Summary for DRH18-00305

The Richardson Design Partnership – Peter Jacobsen, requests Design Review approval to construct a 37-664-square foot, 4-story hotel with site related improvements within the C-2D (General Commercial with Design Review Overlay) zone.

Planning Division Project Report

File Number	DRH18-00305
Applicant	The Richardson Design Partnership / Peter Jacobsen
Property Address	2909 West Elder Street
Public Hearing Date	July 24, 2018
Heard by	Design Review Committee
Design Review Planner	Andrea N. Tuning
Design Review Supervisor	Hal Simmons

ARCHITECTURAL
SITE PLAN

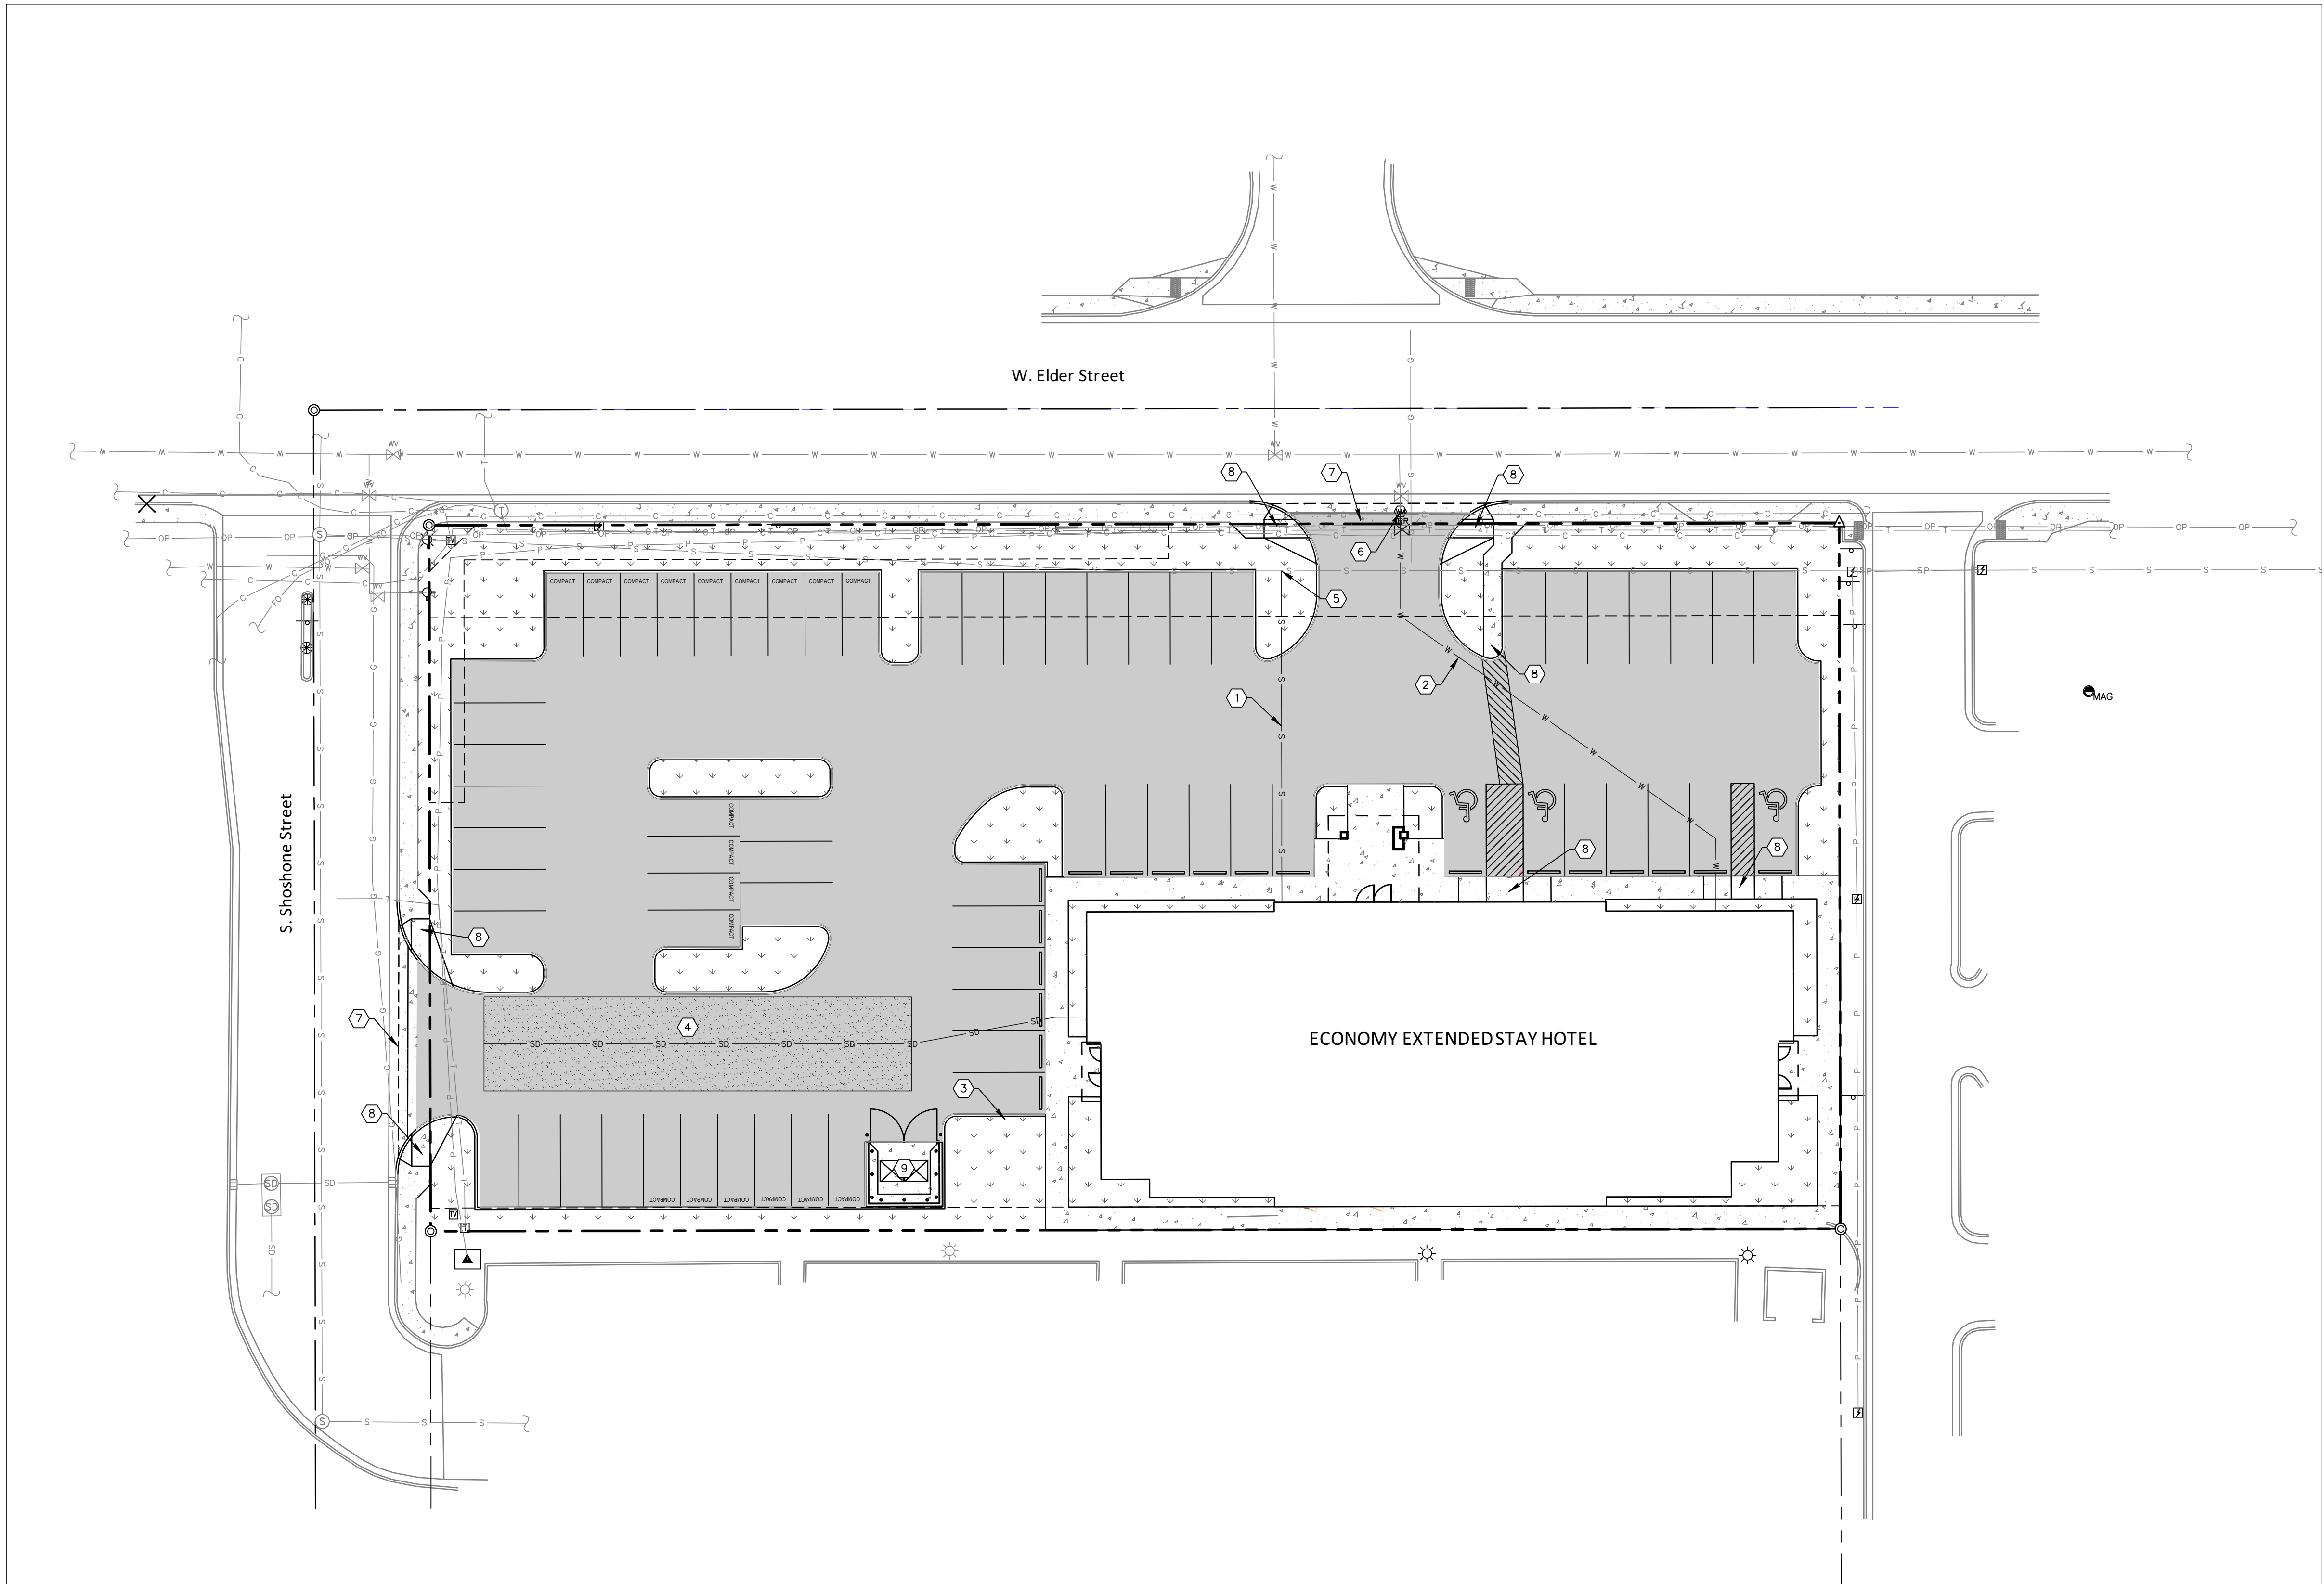
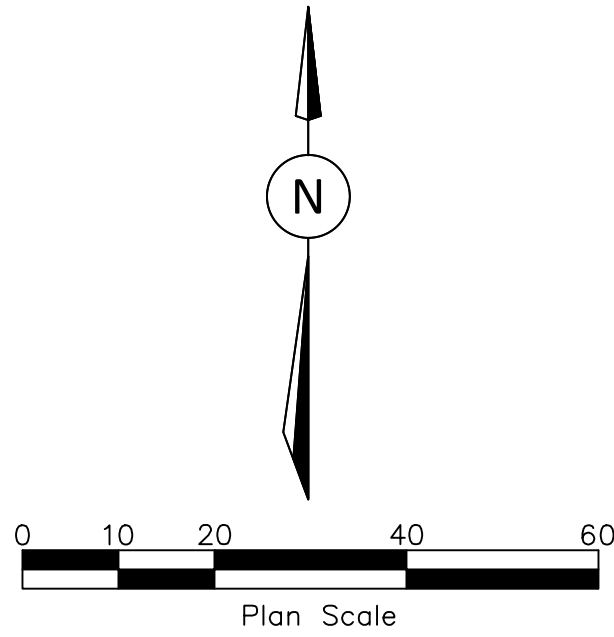
The applicant has identified pole lighting throughout the site located within the setbacks and within planter islands. All light poles and fixtures shall be located outside of the required setbacks and landscape planters which contain trees as required by the landscape ordinance. The lighting shall also not spill onto the adjacent residential property to the east.

The submitted site plan does not meet the required setbacks of the C-2 zone. The applicant will be required to provide a 10-foot parking setback from the west property line and a 5-foot parking setback from the south and east property lines.

The ordinance requires 1 bicycle parking space for every 10 vehicle spaces required. As such, the applicant will be required to provide 7 bicycle parking spaces on the site conveniently located and visible to individuals utilizing alternative modes of transportation. The applicant has not provided any bicycle parking spaces. With the minor modifications required, the number, dimension and location of bicycle and parking spaces proposed with this application comply with ordinance standards (3.3 and 11-07-03).

The two mechanical units proposed to service the site are located at grade on the south side of the building. The site plan identifies it being screened utilizing mechanical screening however, the screening method is not identified. The applicant will be required to provide full height screening for the mechanical units located on the site side of the building. The proposed screening method shall be reviewed and approved by the Design Review Division prior to issuance of a building permit.

- a. The site plan and landscape plan shall match one another.
 - b. Provide a 10-foot parking setback from the west property line.
 - c. Provide a 5-foot parking setback from the south property line.

- d. Provide a 5-foot parking setback from the east property line.
 - e. Remove the existing 5-foot wide attached concrete sidewalk on Elder Street and install a new 5-foot wide concrete sidewalk that is separated from the curb line a minimum of 8-feet or an attached 7-foot concrete sidewalk.

- f. Provide between 67 and 100 parking spaces. This will require the appropriate amount of accessible spaces being provided on site.
 - g. Provide a minimum of 7 bicycle parking spaces on the site. The applicant will be required to design the spaces to be within 50-feet of the main entrance, a minimum of 6 feet long and 2.5 feet wide and have an overhead clearance of 7-feet if covered. A 4-foot wide aisle is required between rows of bicycle parking or nearby walls. Stationary racks shall be located on improved non-permeable surfaces and anchored to the ground.

- q. Provide full height screening for the mechanical units located on the site side of the building. The proposed screening method shall be reviewed and approved by the Design Review Division prior to issuance of a building permit.

- r. All light poles and fixtures shall be located outside of the required setbacks and landscape planters which contain trees as required by the landscape ordinance. The lighting shall also not spill onto the adjacent residential property to the east.

ECONOMY EXTENDED STAY HOTEL
SE OF W ELDER ST. AND S SHOSHONE ST.
LANDSCAPE PLAN

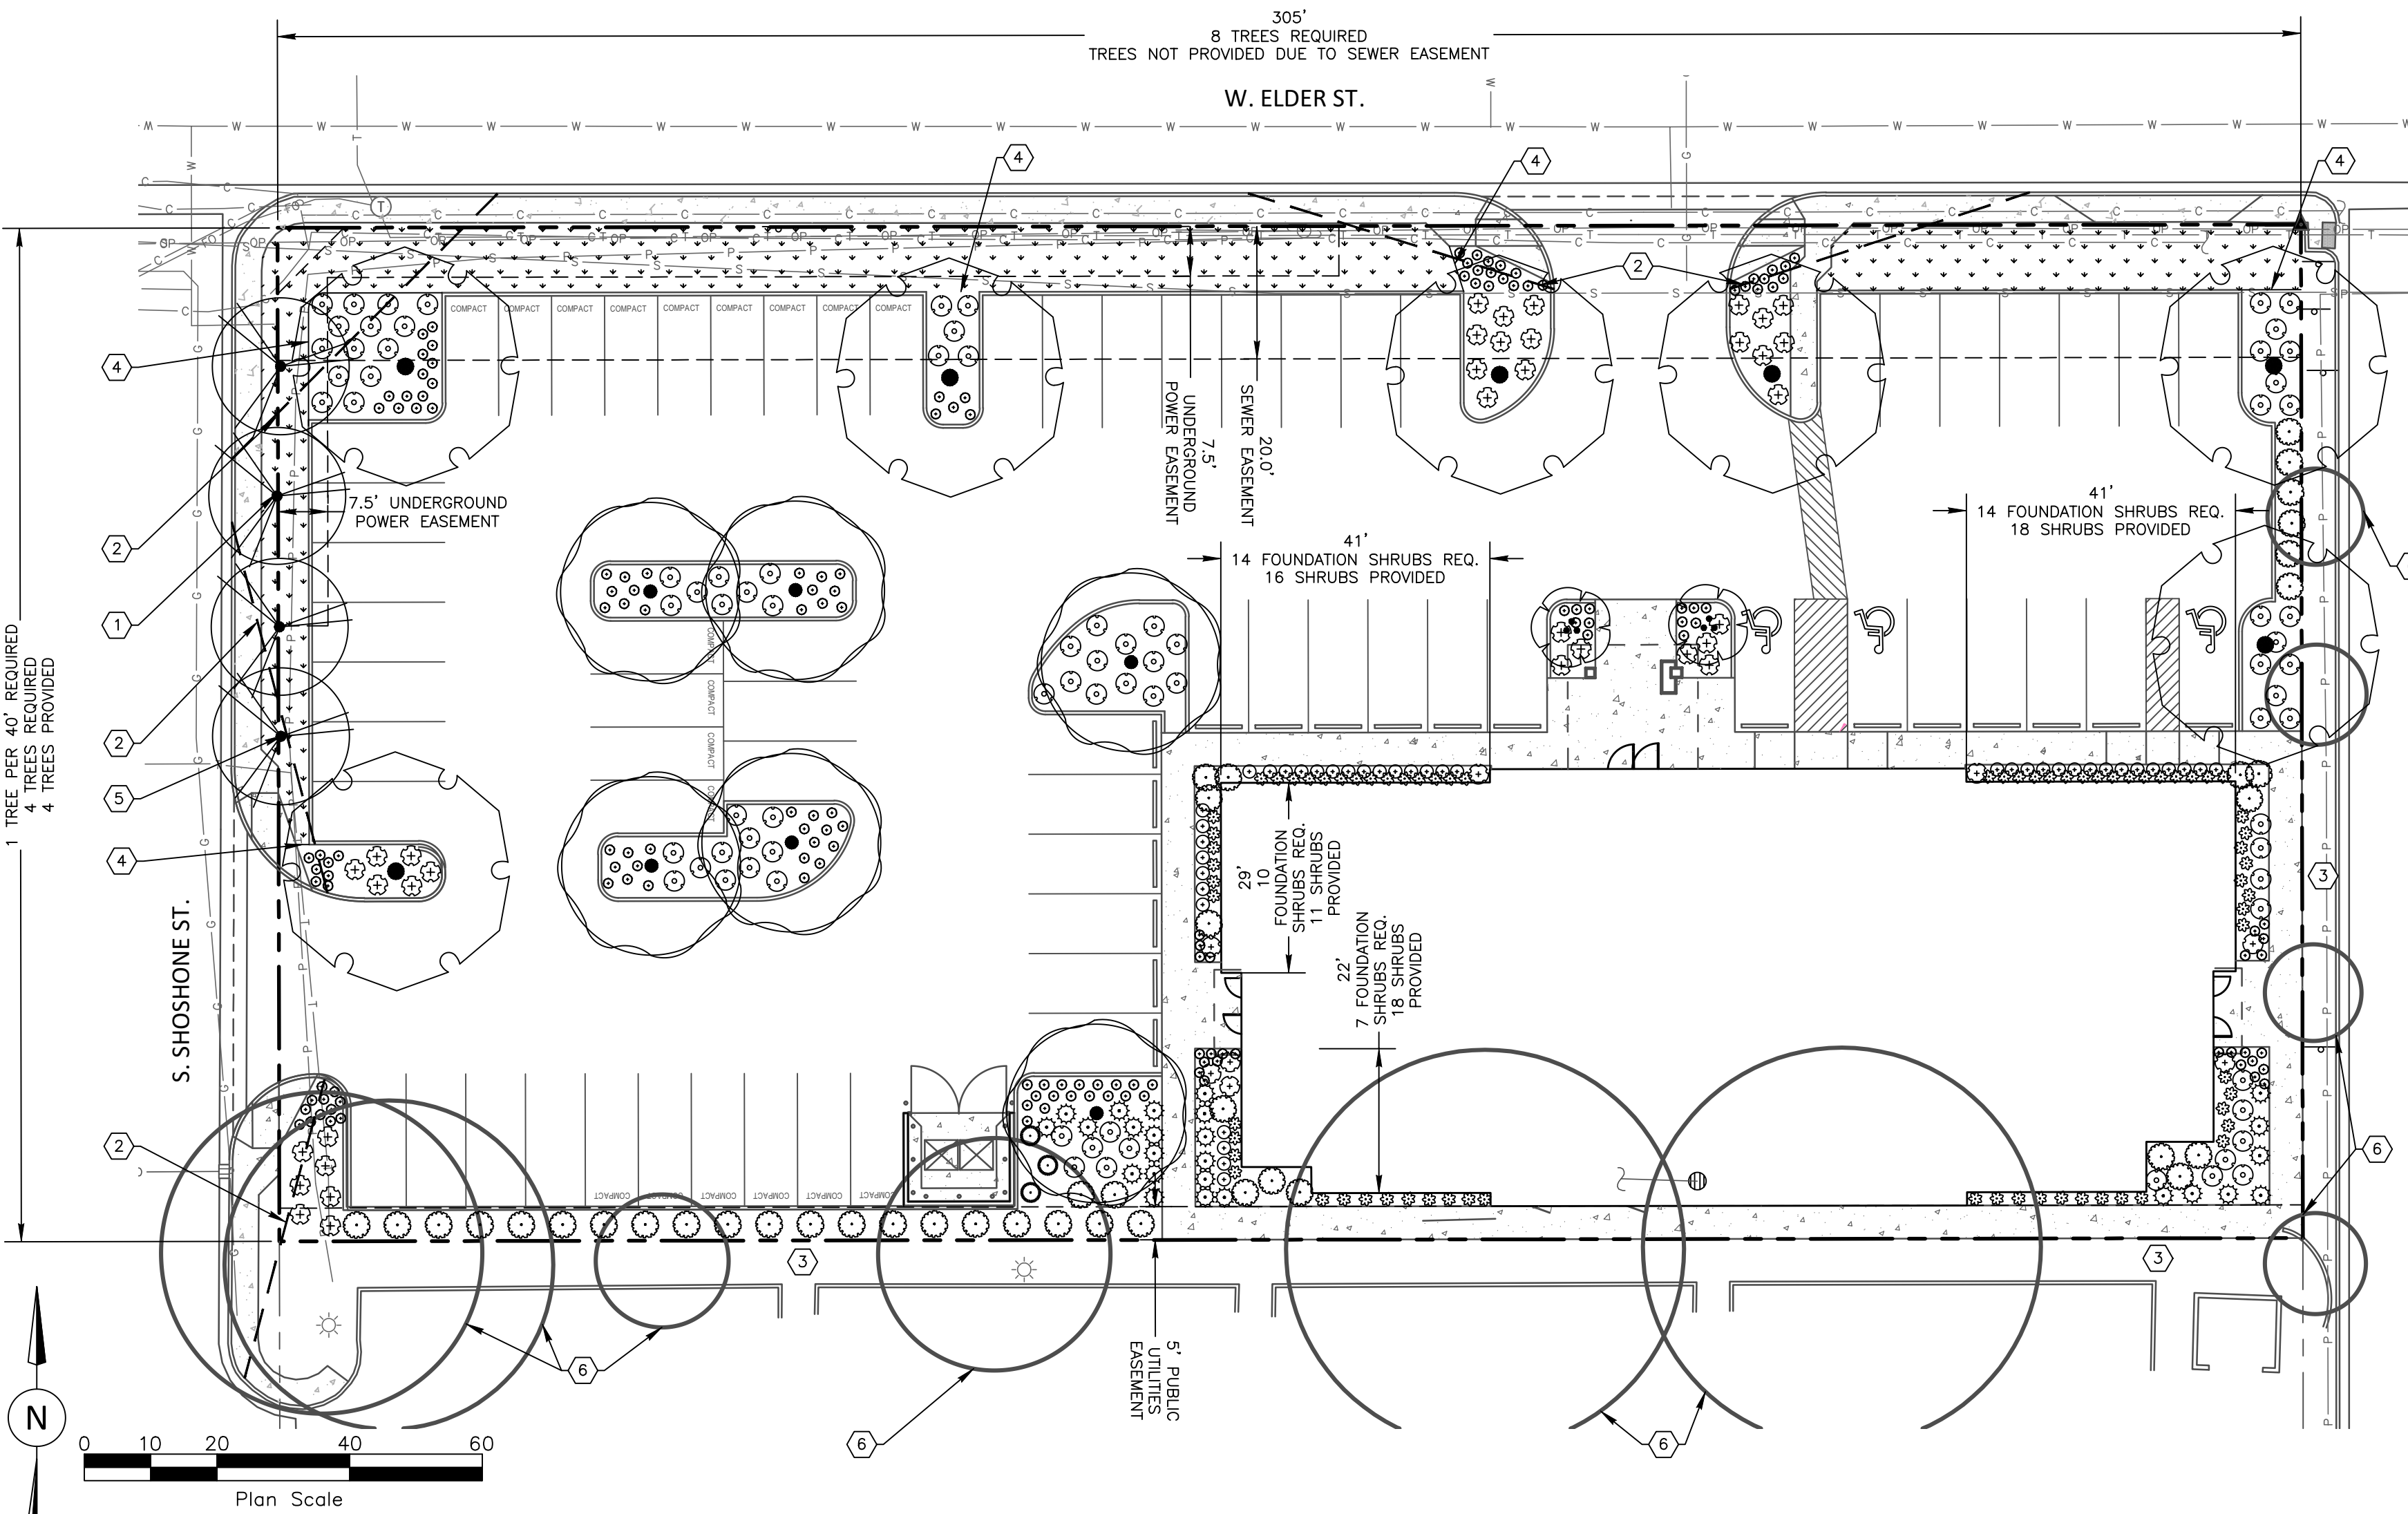
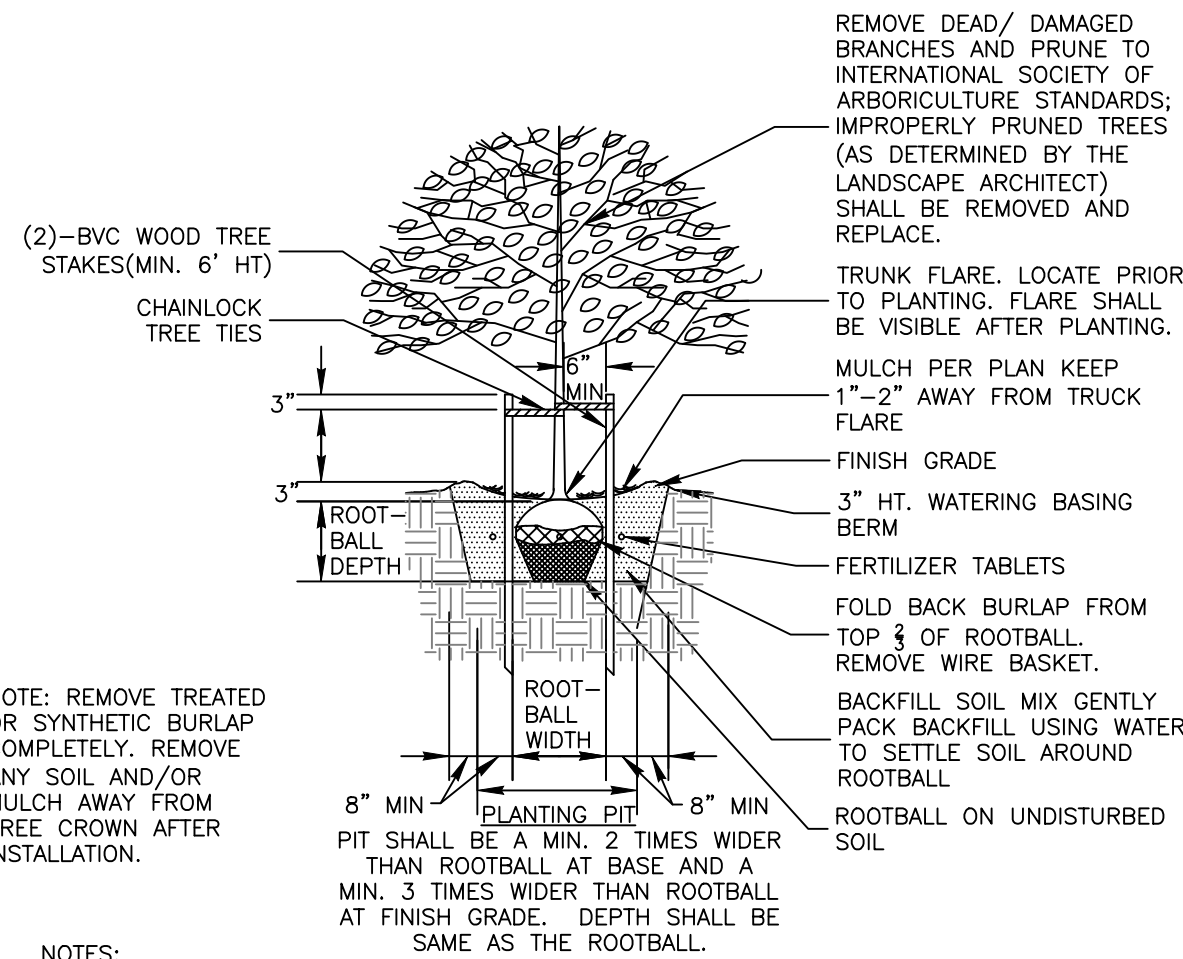
The submitted landscape plan includes a significant amount of turf grass with trees, shrubs and grasses along Elder Street and Shoshone Street, within the planter islands throughout the parking area and adjacent to the building.

Section 11-07-05.D.1.C requires one Class II or Class III street tree be provided for each 40-linear feet of street frontage. The applicant is not proposing to install any street trees along Elder Street due to the fact there is a sewer easement that runs along Elder Street. Section 11-07-05.2.B.8 requires Class I street trees be provided when overhead utilities are present. It also states if an underground easement precludes the planting of trees, the landscape buffer will be required to be increased to accommodate the required trees. To comply with the current landscape ordinance, the applicant will be required to install 8 Class I trees along Elder Street. The landscape buffer on Elder Street will be required to be increased to accommodate the required trees. The street trees on Elder Street and Shoshone Street shall be spaced no closer than 80% of the average mature width of the trees.

north side of the building exceeds 10 spaces. As such, the applicant will be required to install an additional interior planter island to be a minimum of 8-feet in width (measured inside of curb to inside of curb) and run the entire length of the parking stall to break up the long row of parking. Also, the double terminal planter located in the northwest corner of the site should contain two trees. This will provide one Class II tree for each row of parking.

- h. Provide an easement from the property owner to the south allowing the 5-foot wide pedestrian connection to connect the two properties.
 - i. Install 8 Class I trees along Elder Street. The landscape buffer on Elder Street will be required to be increased to accommodate the required trees.

- j. The street trees on Elder Street and Shoshone Street shall be spaced no closer than 80% of the average mature width of the trees.
 - k. Install an additional interior planter island within the parking row adjacent to the building. The planter islands shall be a minimum of 8-feet in width (measured inside of curb to inside of curb) and run the entire length of the parking stall to break up the long row of parking.

- l. Install a second tree within the "double terminal planter" located in the northwest corner of the site.
